RE: Western Sydney Aerotropolis

I refer to the exhibition of various strategic planning documents concerning the Western Sydney Aerotropolis, including the Draft Western Sydney Aerotropolis Plan (Draft WSAP), Western Sydney Aerotropolis Discussion Paper on the proposed State Environmental Planning Policy (SEPP Discussion Paper) and Draft Western Sydney Aerotropolis Development Control Plan (Draft DCP) Phase 1.

Attachment A

Map 1. Extract from Figure 8-1 of Penrith Council 2019 South Creek Floodplain Risk Management Study.

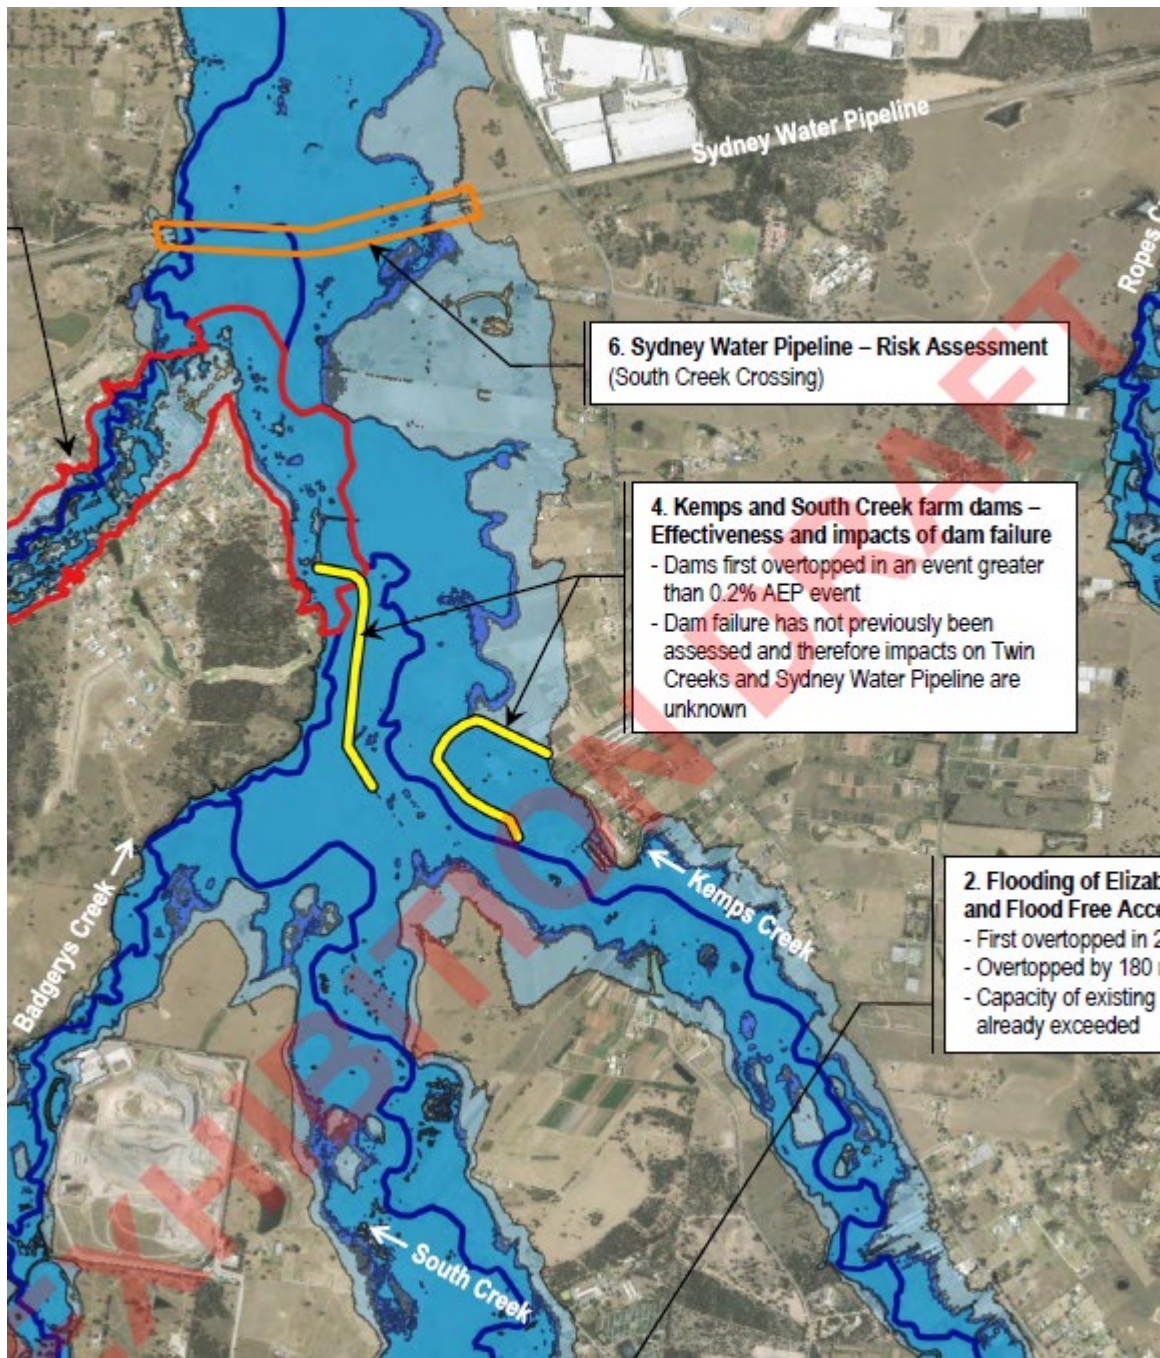
4. Two major farm dams in the adjoining Twin Creeks area have not been assessed for their risk of dam failure even under existing land uses (see Callout-Box 4 of Figure 8-1 of the Penrith Council 2019 South Creek Floodplain Risk Management Study, extract provided in Map 1 attached). The South Creek Floodplain Management Study indicated that these dams first overtopped in a greater than 0.2% AEP Event. Any increase in stormwater runoff arising from the Aerotropolis has the propensity to exacerbate the risk of these dams collapsing. The risk of these dams collapsing needs to be included in a stormwater and flood-risk management study suggested above, and based on the proposed land uses.
